[Docket No. 2003-NE-52-AD; Amendment 39-13381; AD 2003-24-12]

Airworthiness Directives; Pratt & Whitney JT9D-3A, -7, -7A, -7F, -7H, -7AH, and -7J Turbofan Engines

ACTION: Final rule; request for comments.

Figure 1

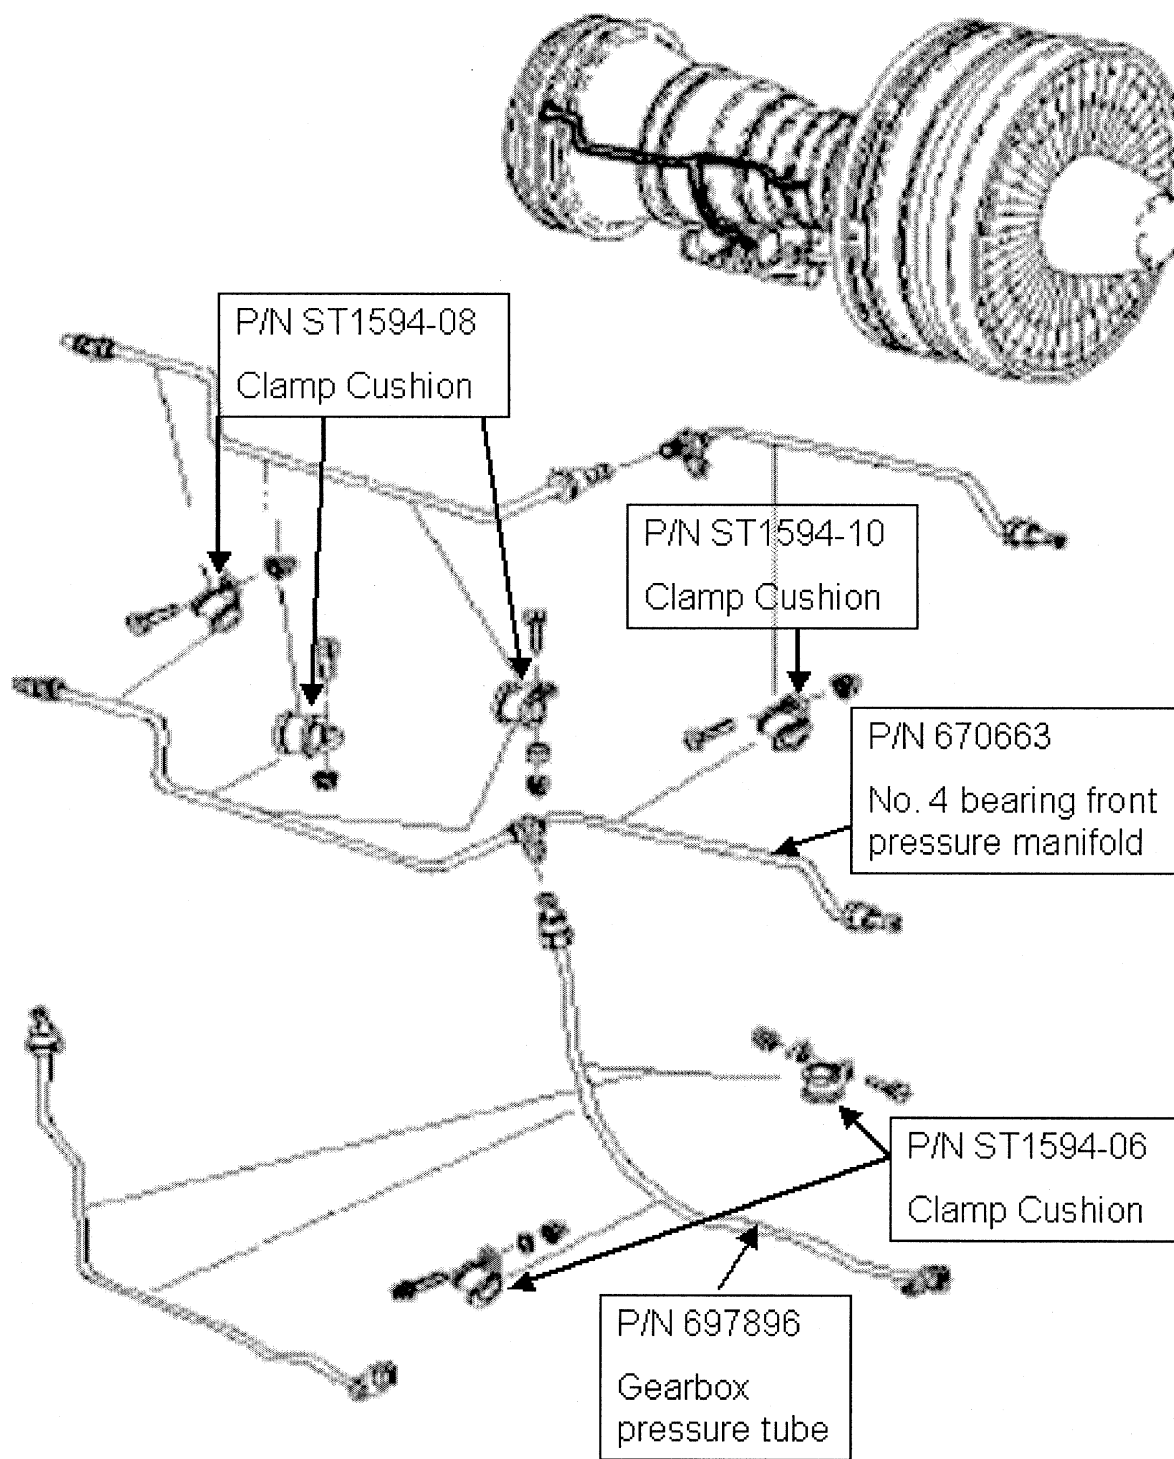
(h) If the gearbox pressure tube, No. 4 bearing front pressure manifold, or clamp assemblies are not properly positioned, then correctly position them before further flight, as shown in the following Figure 1 of this AD.
